Addendum # 004

TENDER NUMBER: 619-CP2003

Renovations and Atrium Project

Our Lady of Fatima Catholic School

DATE PLOTTED 20/03/2020 1:15:14 PM	DRAWN BY TJV/WPC	DRAWING No.
SCALE As indicated	CHECKED BY RRW	A151
PROJECT No.		1901

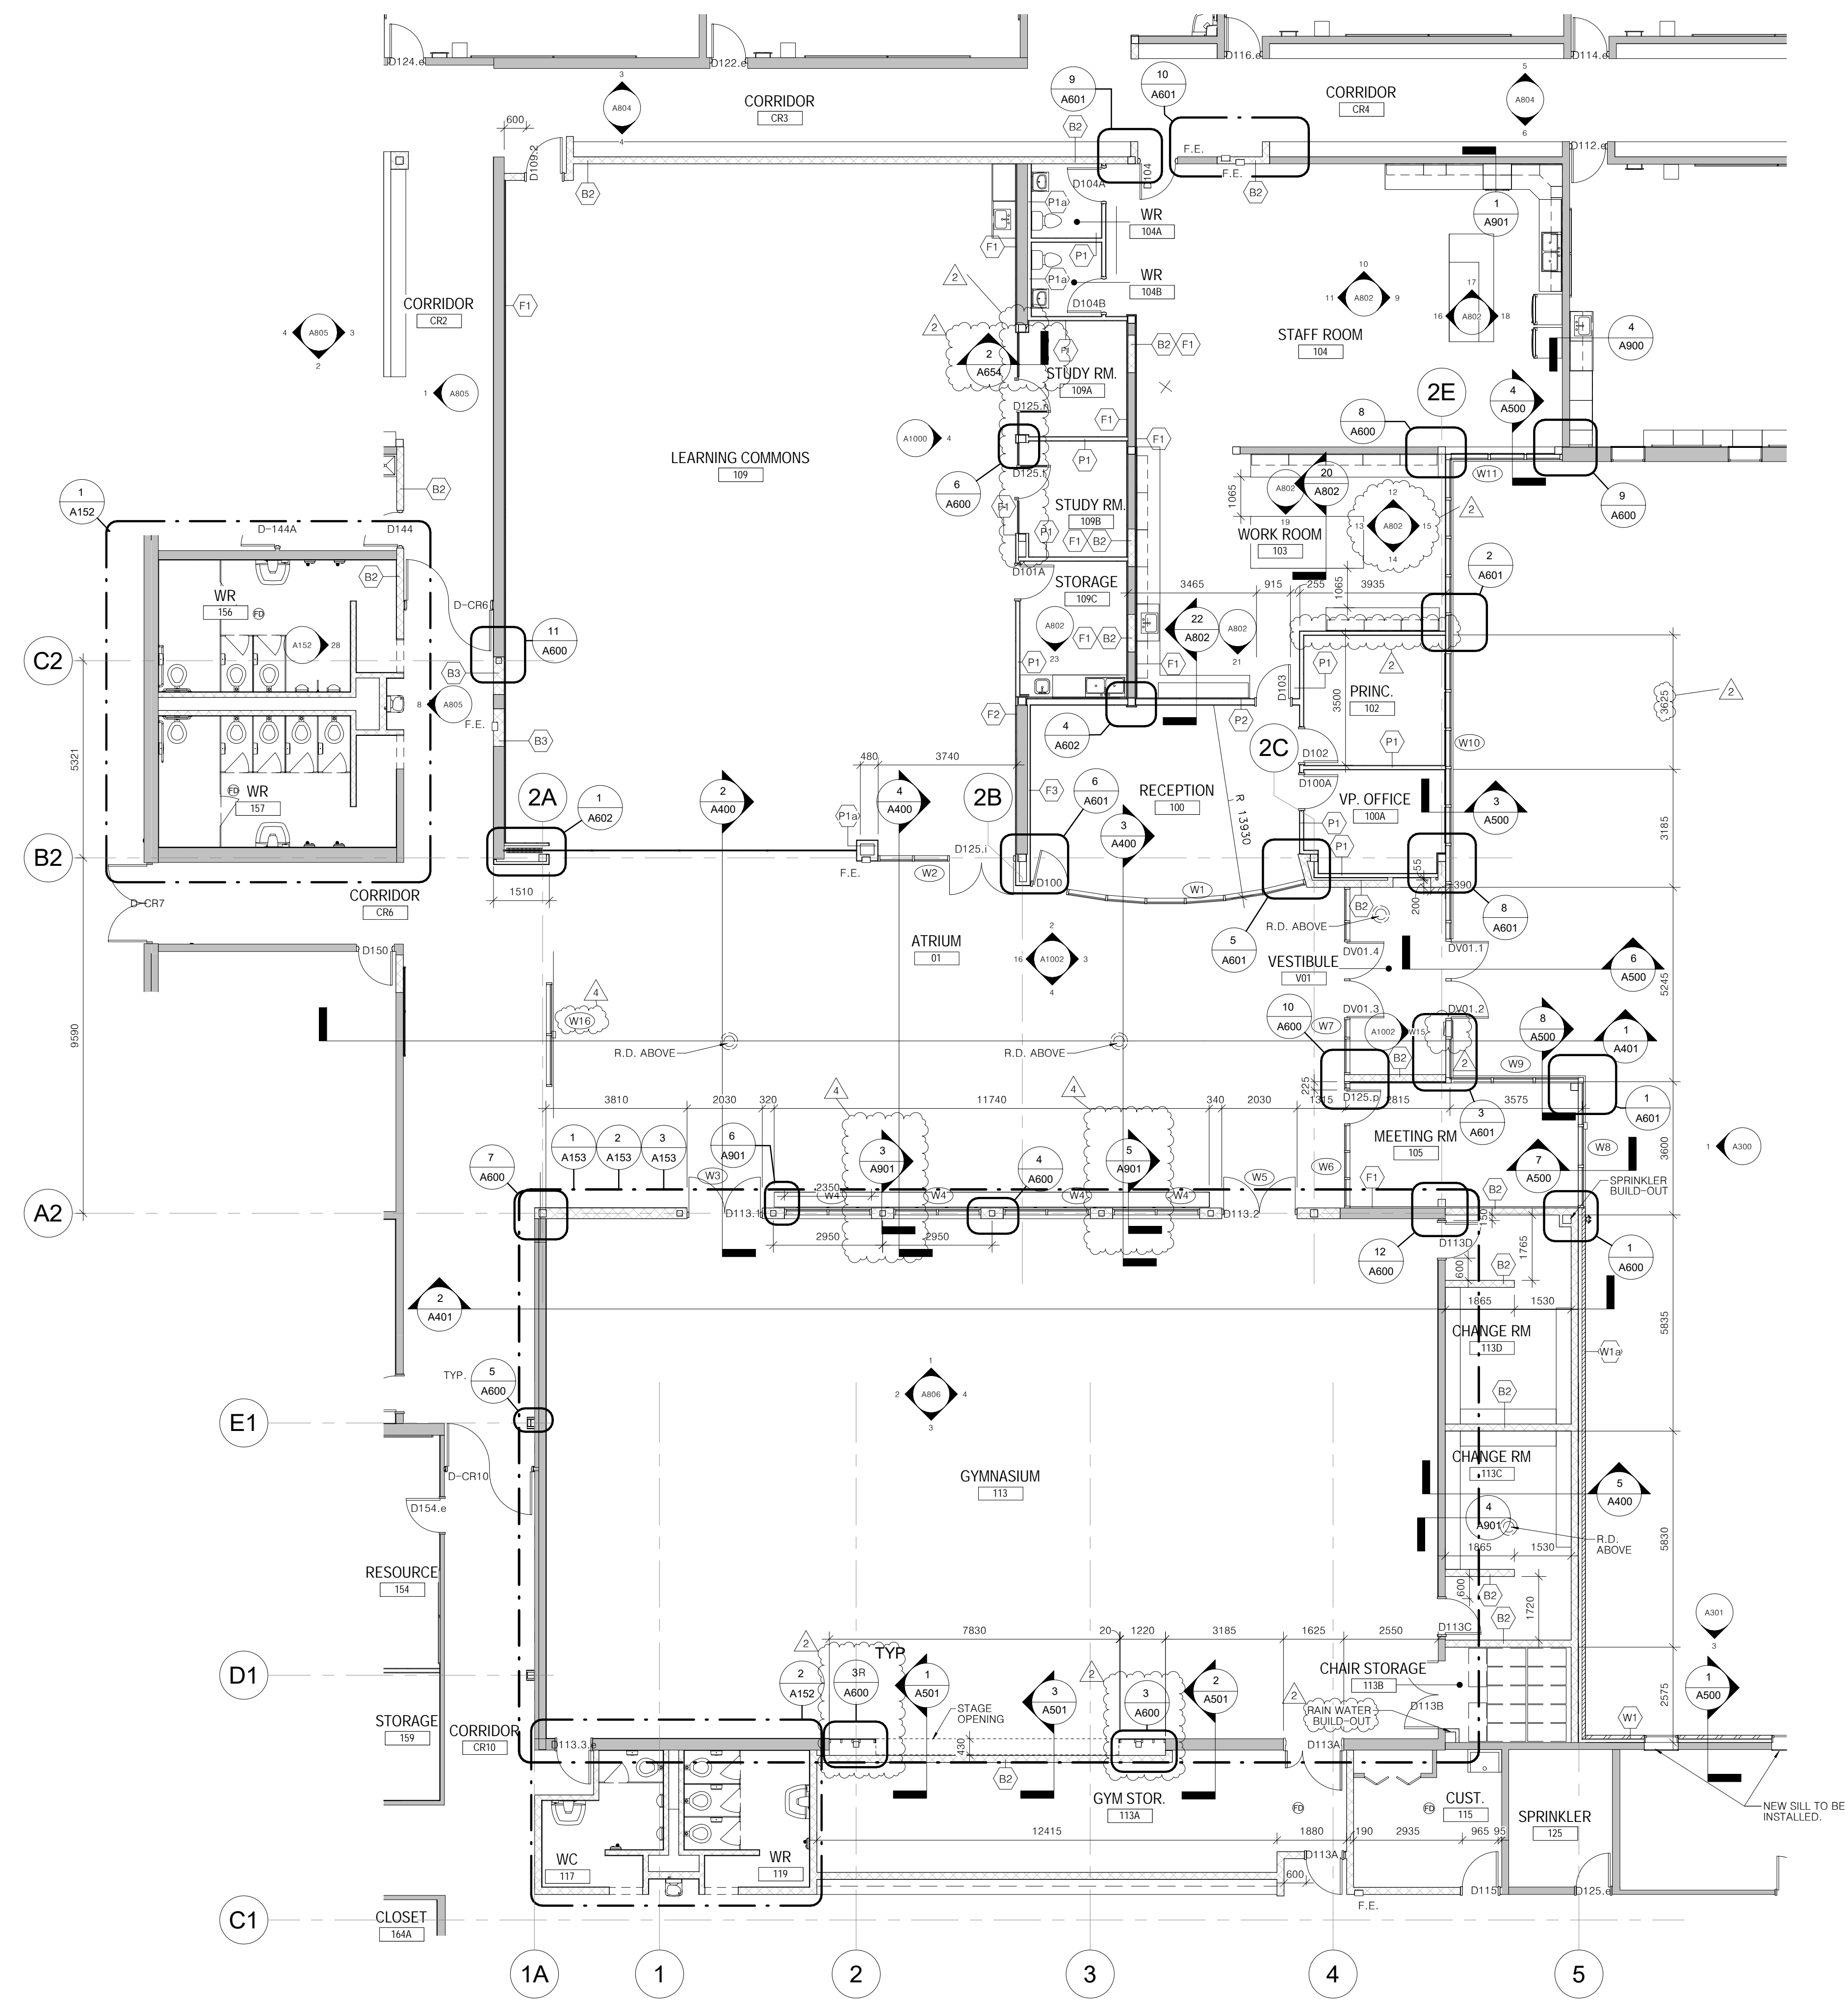
- Q36: Could you clarify if it is aluminium or Hollow Metal frame. Drawing A1000 shows W5, W4 and W3 as aluminium frame, but drawing 3-A400 and drawing A1000 on schedule doors for corresponding frame (D113.1 and D113.2) says it is H.M.

- A36: Question is confusing but, Drawing A151 and A803 shows W3, W4 and W5 and are all hollow metal. The schedule is correct D113.1 and D113.2 are hollow metal.

DRAWING TITLE
CONSTRUCTION ROOF PLAN

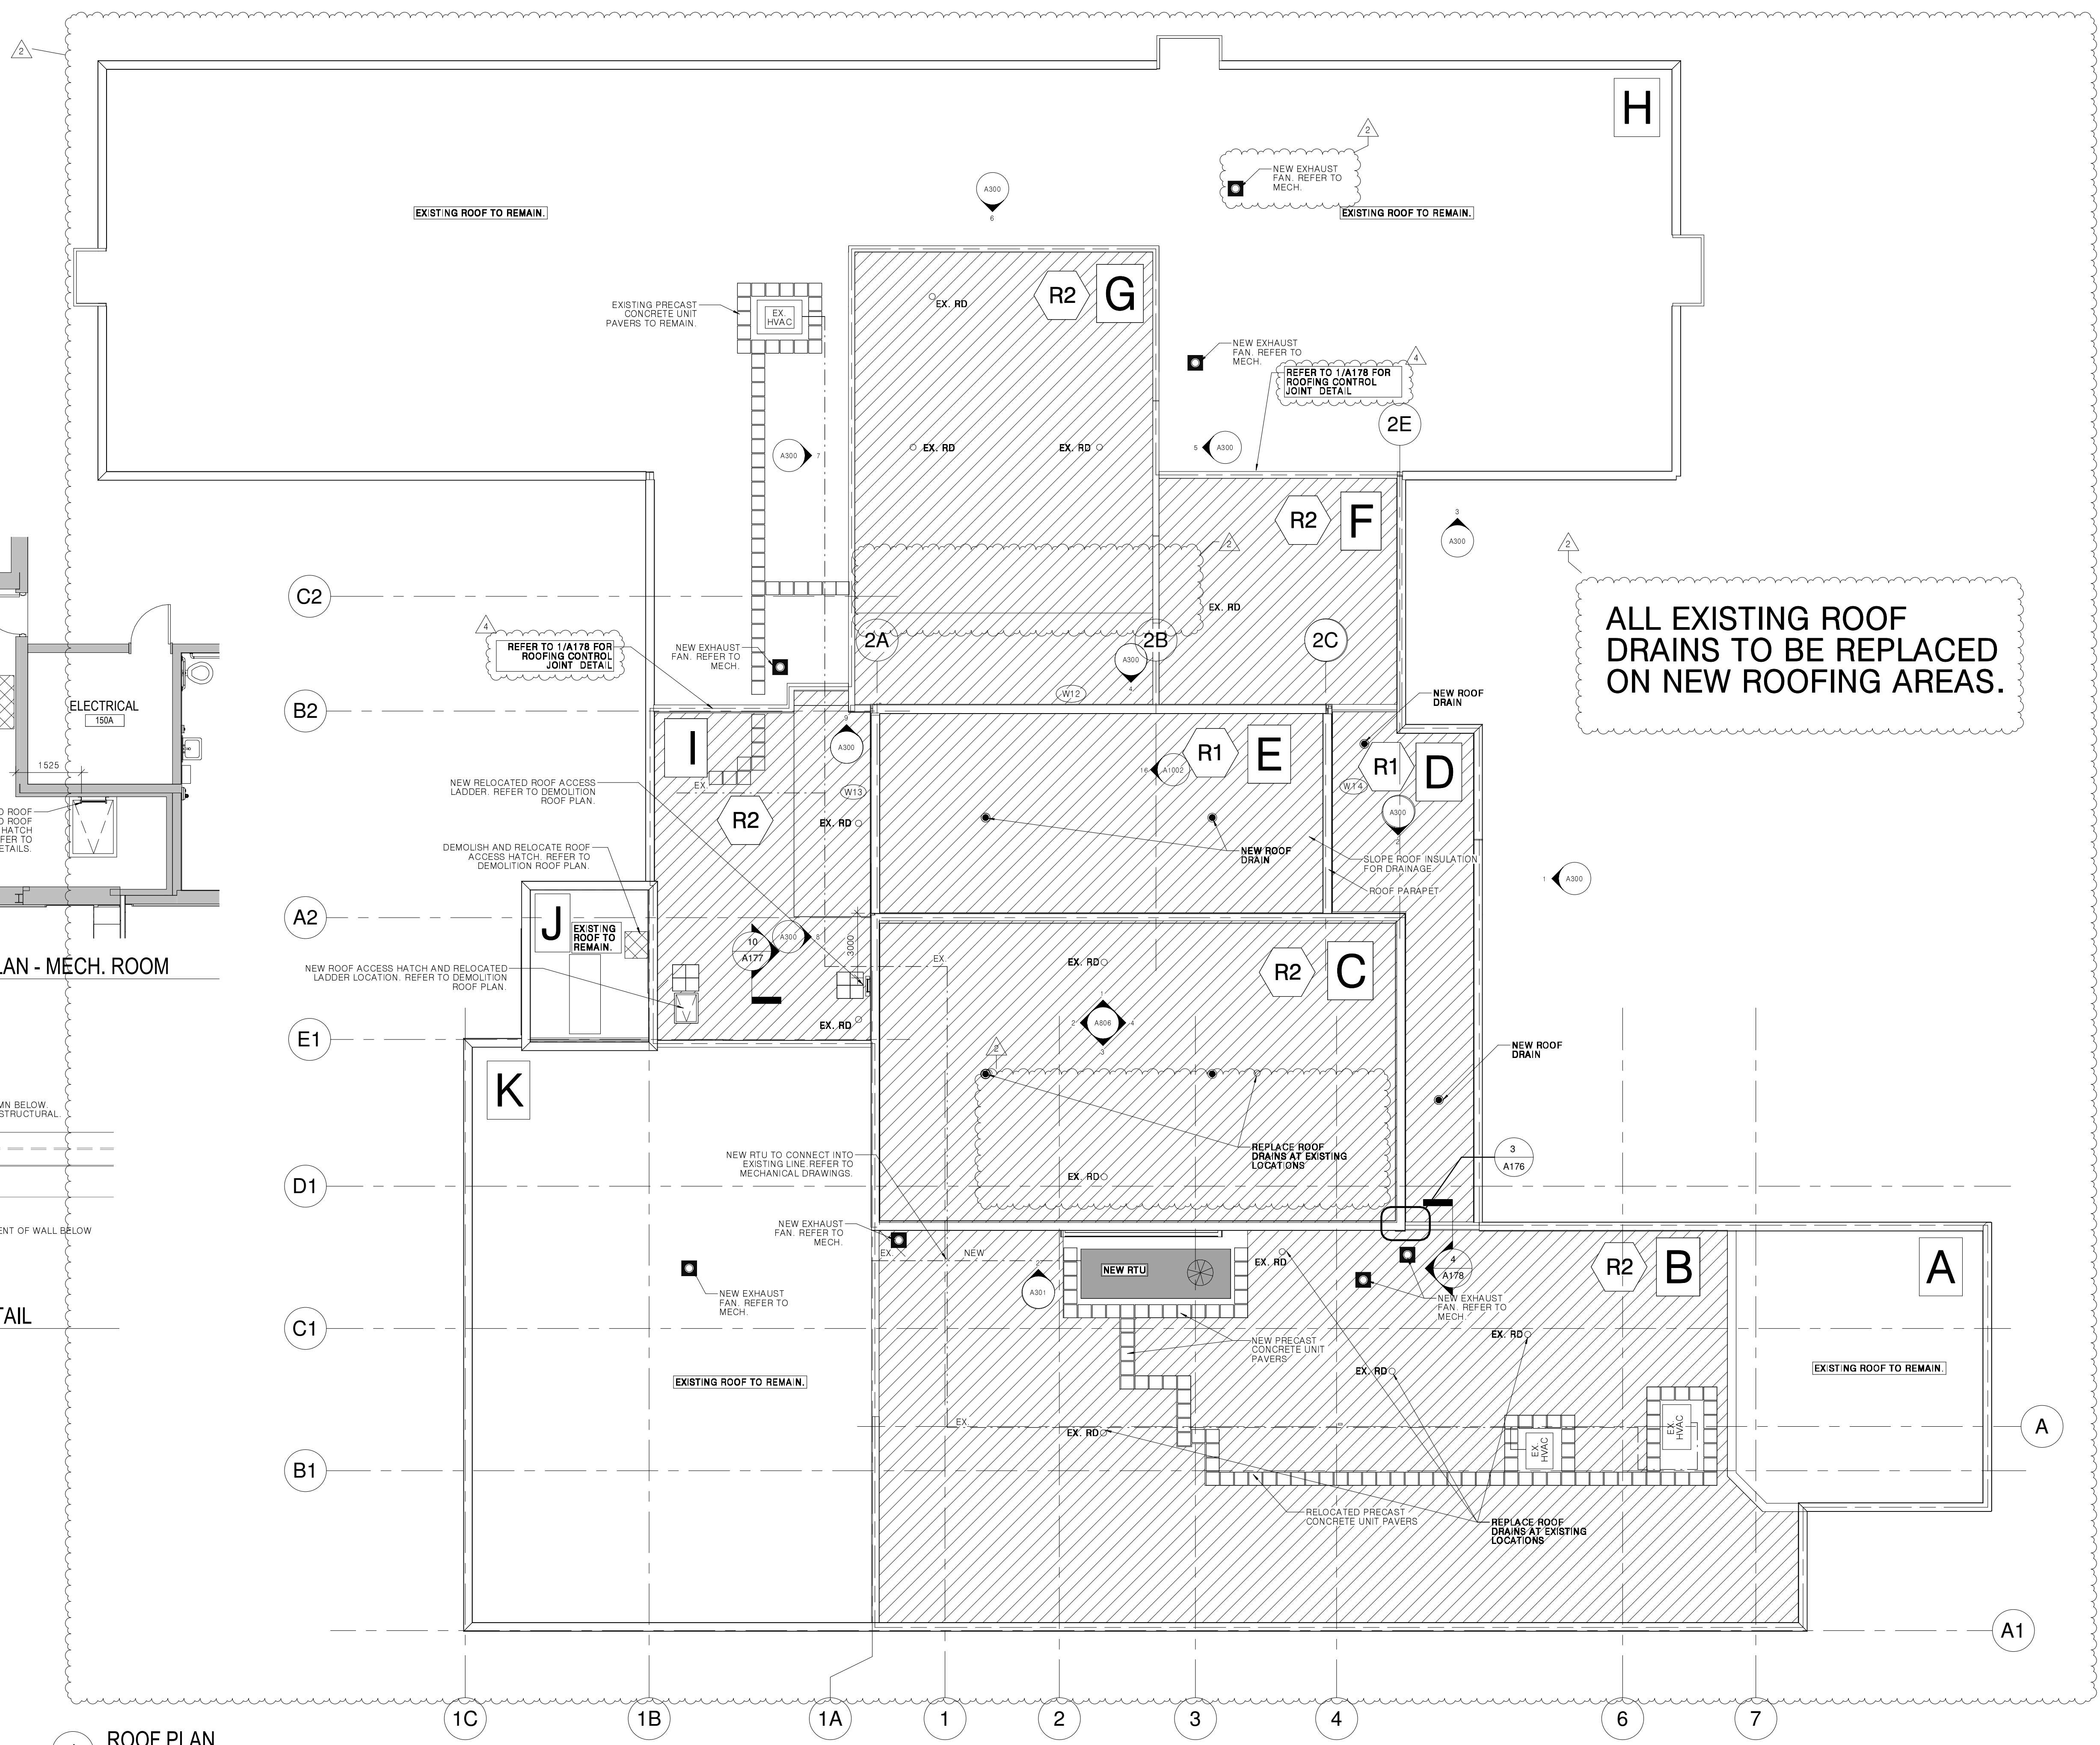
- Q31: The spec section [07 72 33] instructs to re-use the existing roof hatch and railing. The drawing [DWG A175] says “new roof hatch and relocated ladder”. Please clarify.

- A31: Drawing A175 and A176 the intent is to re-use a new roof hatch and ladder and relocate to the new identified location. A175 and A176 is revised to read “Relocated roof hatch and access ladder”.
